ARCOM # A-24-0072

Siegfried Residence
127 El Bravo Way
Palm Beach, FL

Previously Approved Hardscape Plan

Proposed Hardscape Plan

2
H2.1
PROPOSED PERIMETER LANDSCAPE
OPEN SPACE DIAGRAM
SCALE: 1/16" = 1' 0"

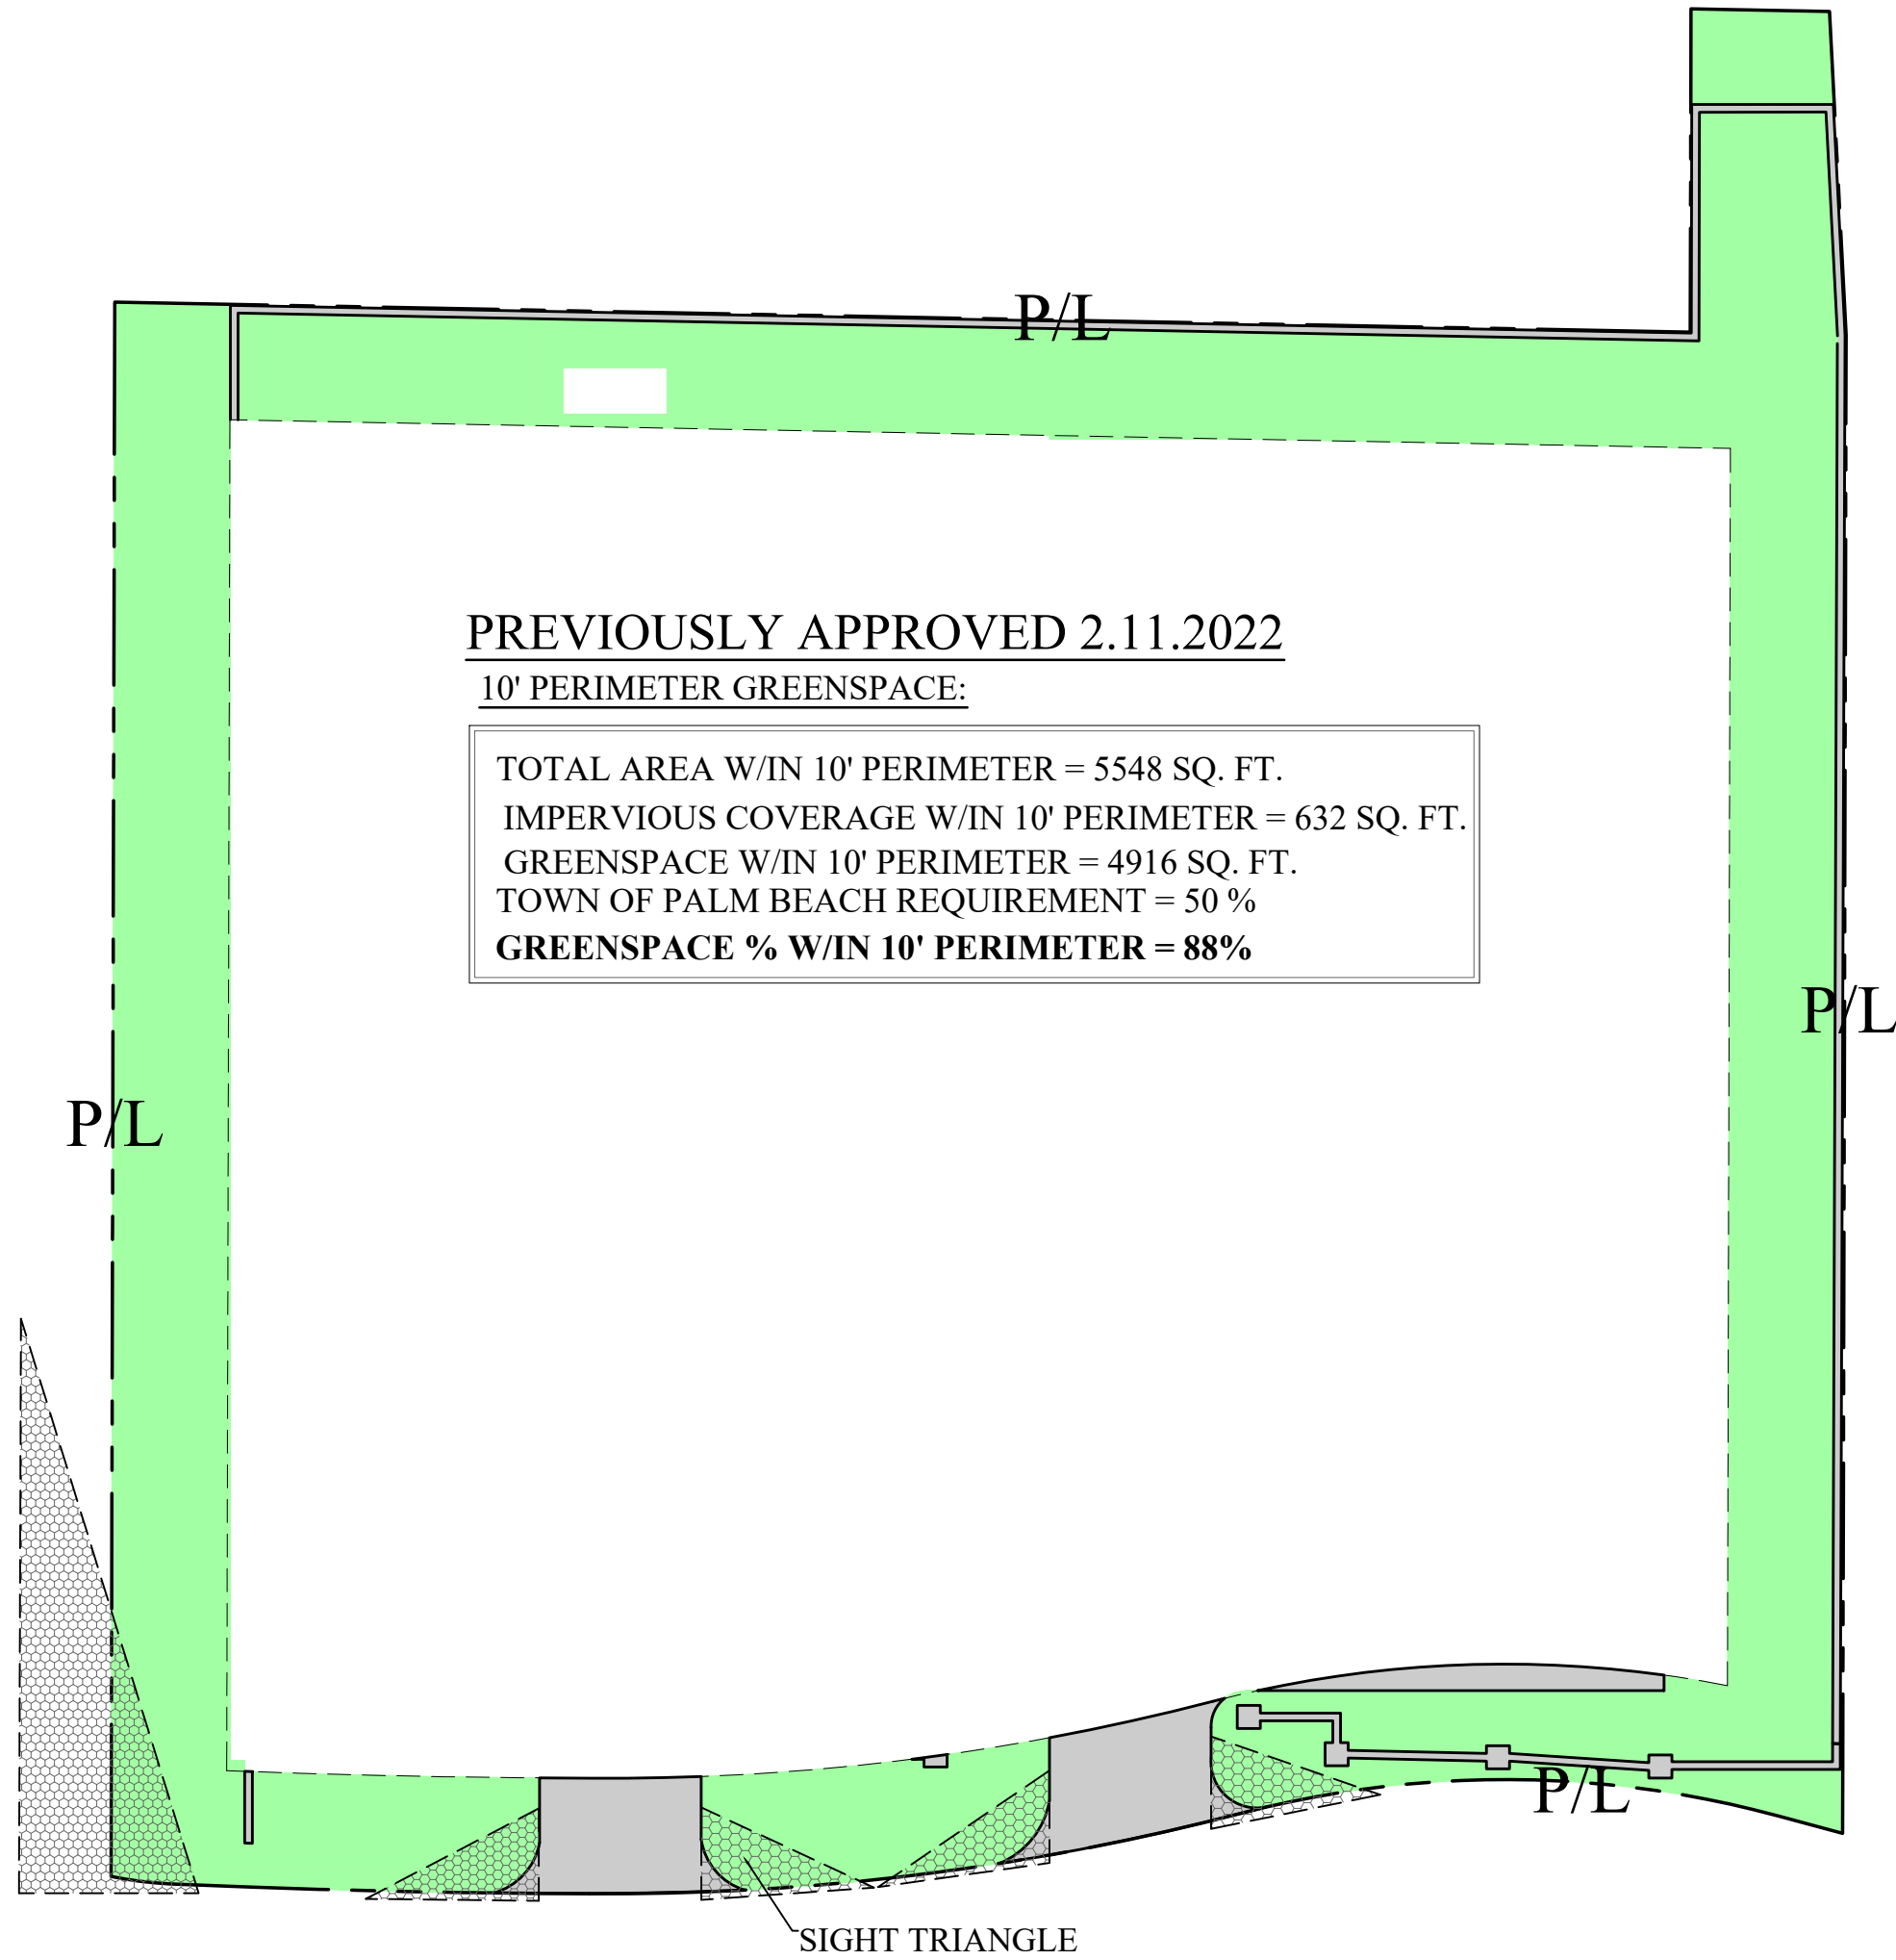
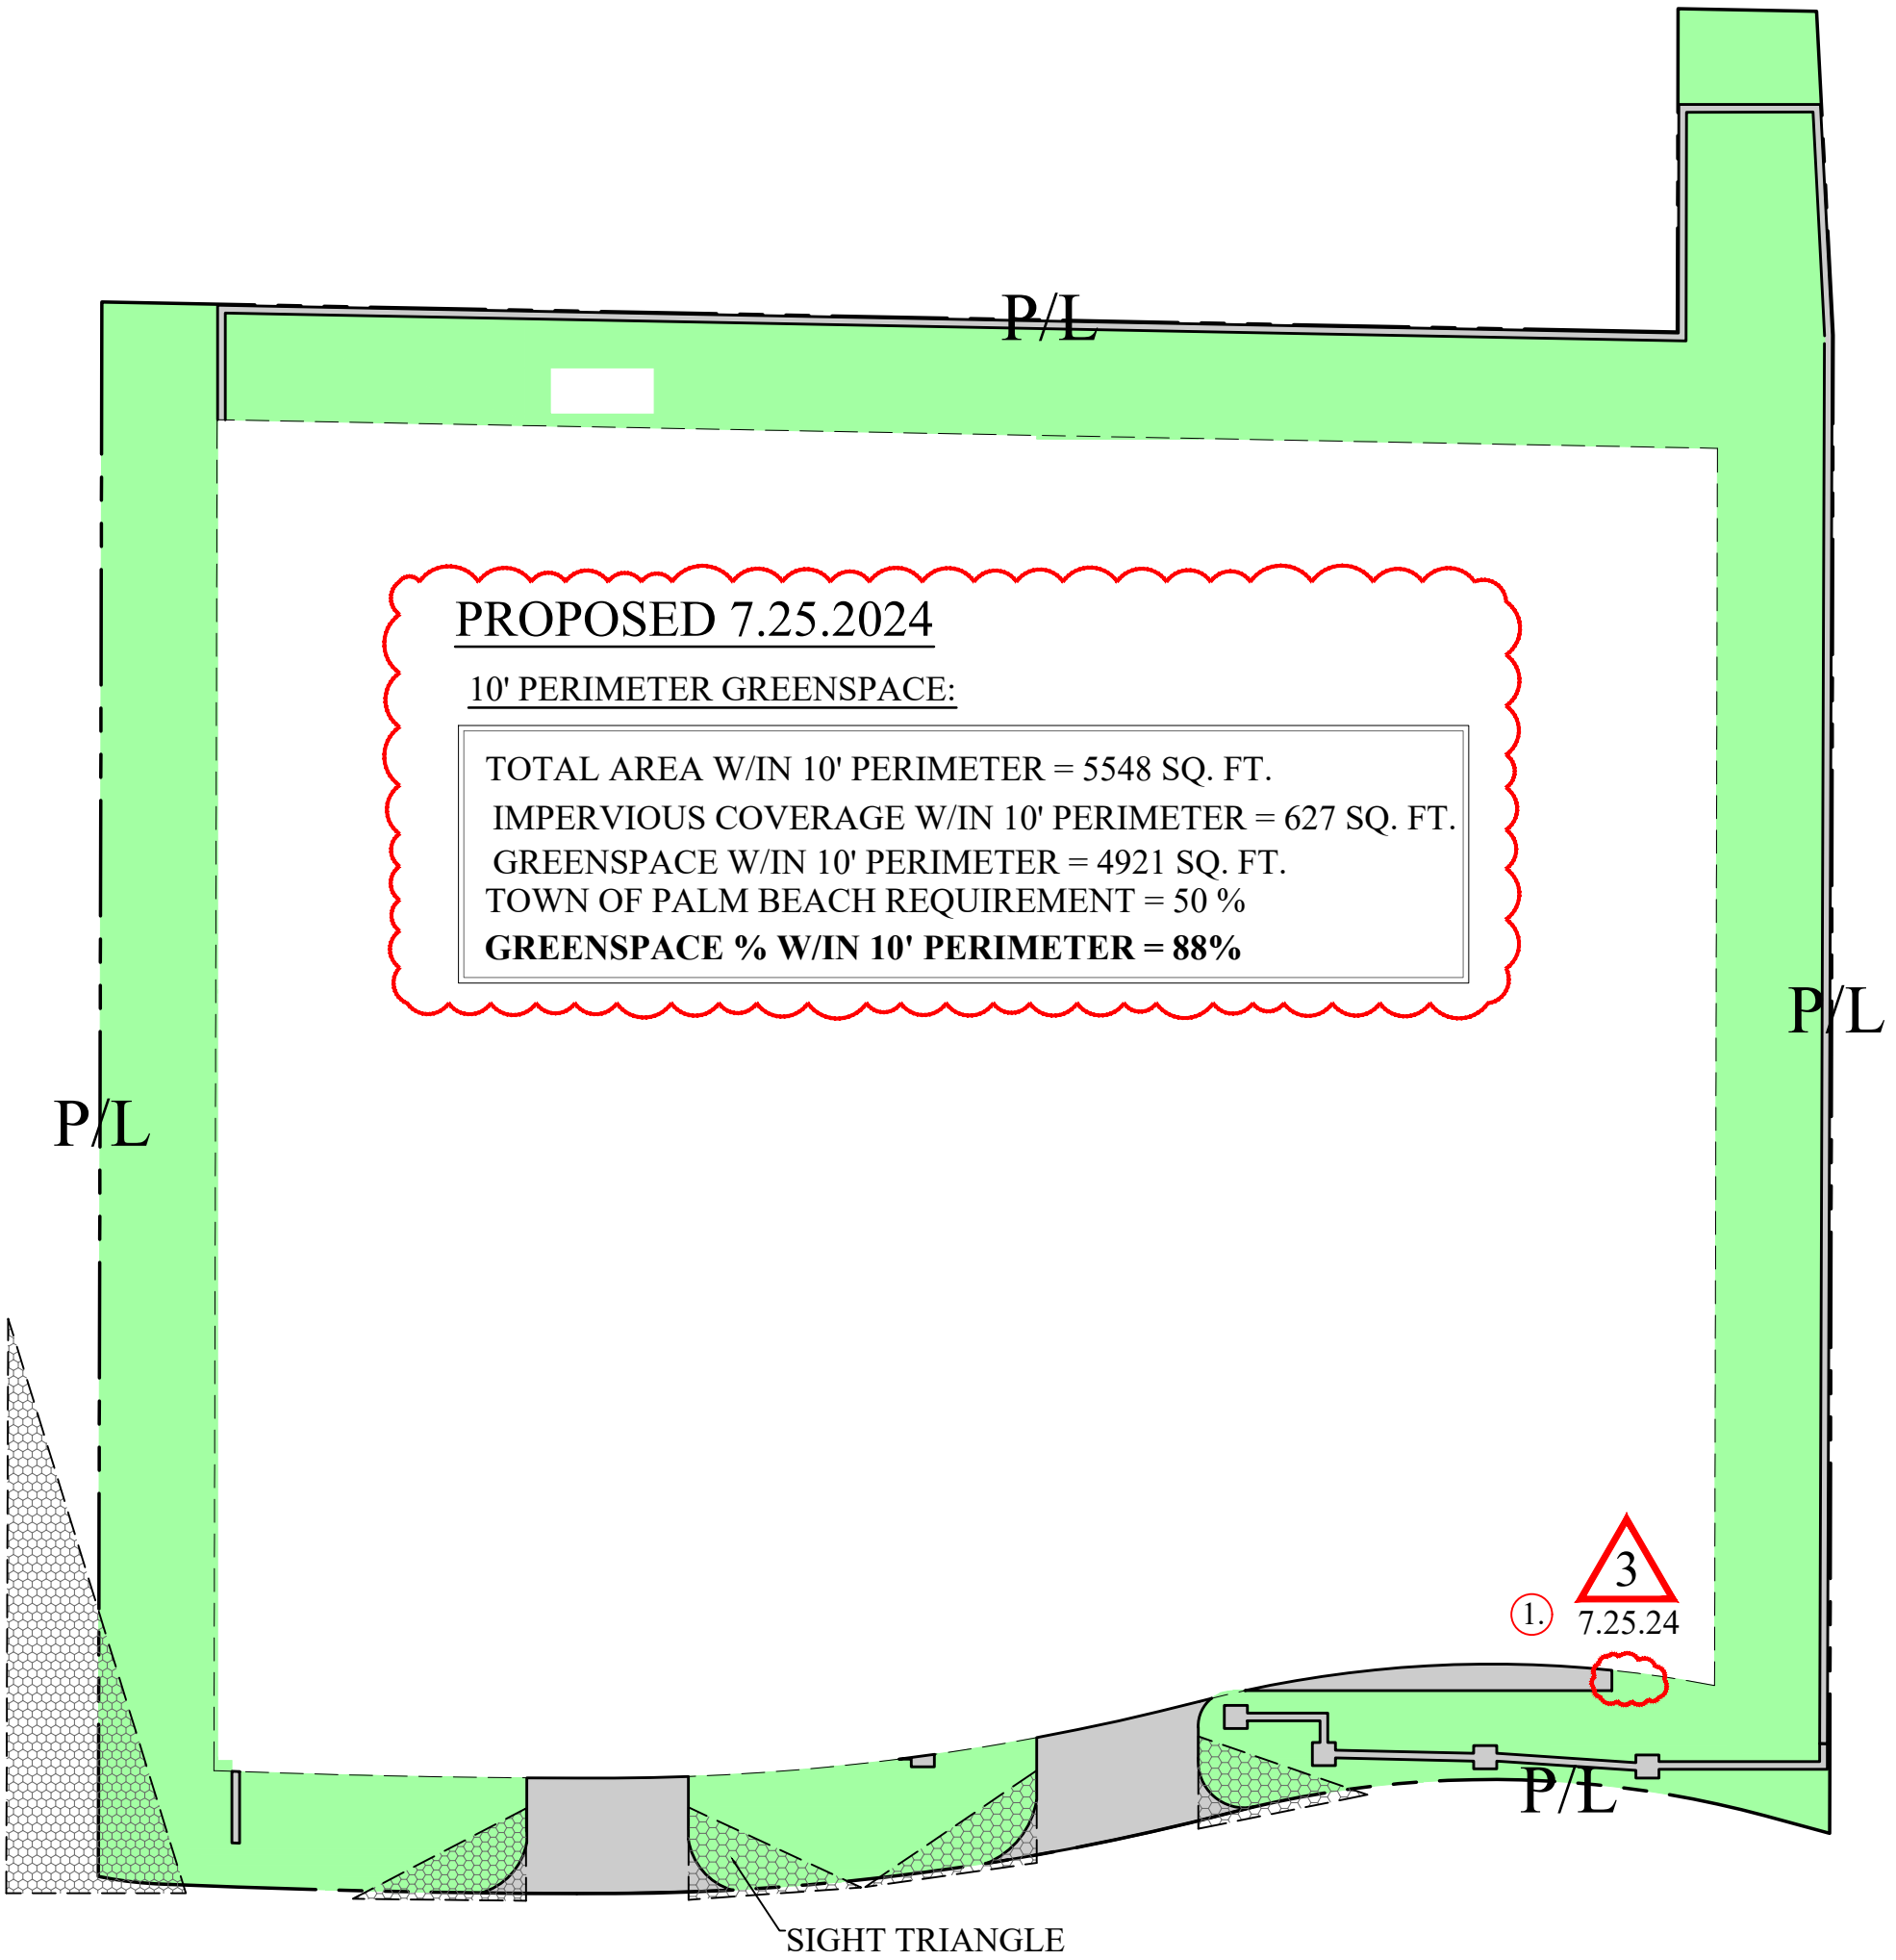
CHANGE LOG

NUMBERS FOR THIS SHEET ONLY

1. REDUCE LENGTH OF DRIVE 3' 5"
2. ADD SMALL PARKING SPACE
3. MOVE GARDEN WALL & GATES
4. NARROW DRIVE 9"
5. EXTEND WALK TO LOGGIA
6. ENLARGE PLANTING PITS
7. REDUCE POOL TERRACE
